NEWMAR CORPORATION WARRANTY DEPARTMENT

TECHNICAL SERVICE BULLETIN						
DATE ISSUED	MODEL YEAR(S) AFFECTED	MODEL(S) AFFECTED	TSB #			
9/14/98	1998-1999	ALL	162			
BRAND		TYPE				
All <input type="checkbox"/>	American Star <input type="checkbox"/>	Kountry Star <input type="checkbox"/>	Dutch Star <input checked="" type="checkbox"/>	All <input type="checkbox"/>	T T <input type="checkbox"/>	F W <input type="checkbox"/>
NewAir <input type="checkbox"/>	Mountain Air <input checked="" type="checkbox"/>	Kountry Air <input checked="" type="checkbox"/>	London Air <input checked="" type="checkbox"/>	C A <input type="checkbox"/>	D P <input checked="" type="checkbox"/>	D B <input type="checkbox"/>
<input type="checkbox"/> Air Conditioning & Heating				<input checked="" type="checkbox"/> Electrical Components		
<input type="checkbox"/> Appliances & Accessories				<input type="checkbox"/> Exterior Components		
<input type="checkbox"/> Cabinets & Furniture				<input type="checkbox"/> Interior Components

NEWMAR CORP P.O. Box 30, Nappanee, IN. 46550 Title block--1-STB	Model: DS/MA/LA DP'S FRIEGHTLINER	Sheet 1 OF 1	Drawn by: MIKE D.	Checked by:	Revision:	By:
	Title: NEWMAR 2-GA. WIRE ADDITION	I.D. # MOT\CODE\ELEC\2GA_WIRE	Date: 9/3/98	Date:	Revision:	Date:
						By:

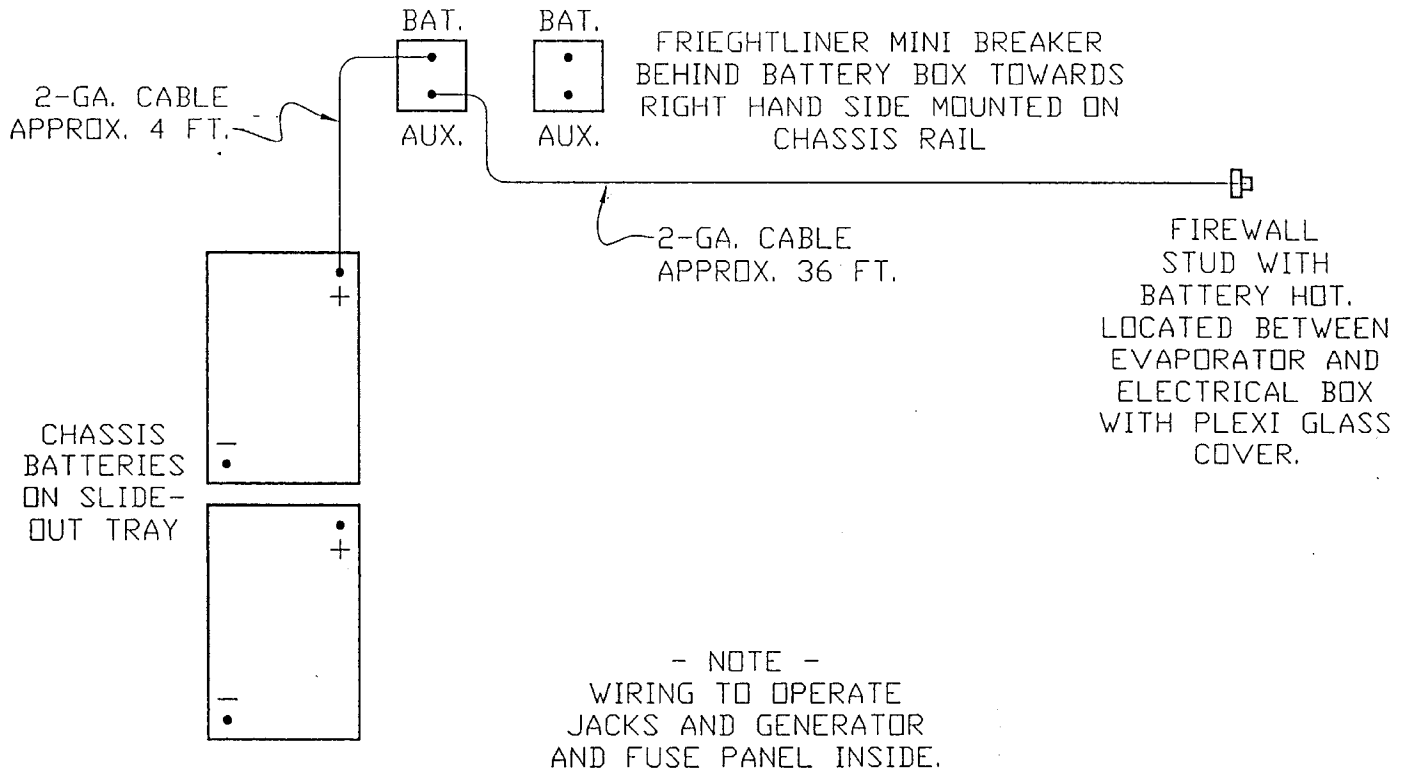
<input checked="" type="checkbox"/> Chassis Components				<input type="checkbox"/> Plumbing & Bath Components		
<input type="checkbox"/> Construction Components				<input type="checkbox"/> Windows, Awnings, Vents, & Doors		
DESCRIPTION OF PROBLEM						
Intermittent operation of jacks and steps caused by low voltage on Freightliner chassis produced from 9-97 – 9-98.						
RECOMMENDED SOLUTION						
Inspect wiring from battery to front fuse panel for proper gauge wires. See the attached diagram.
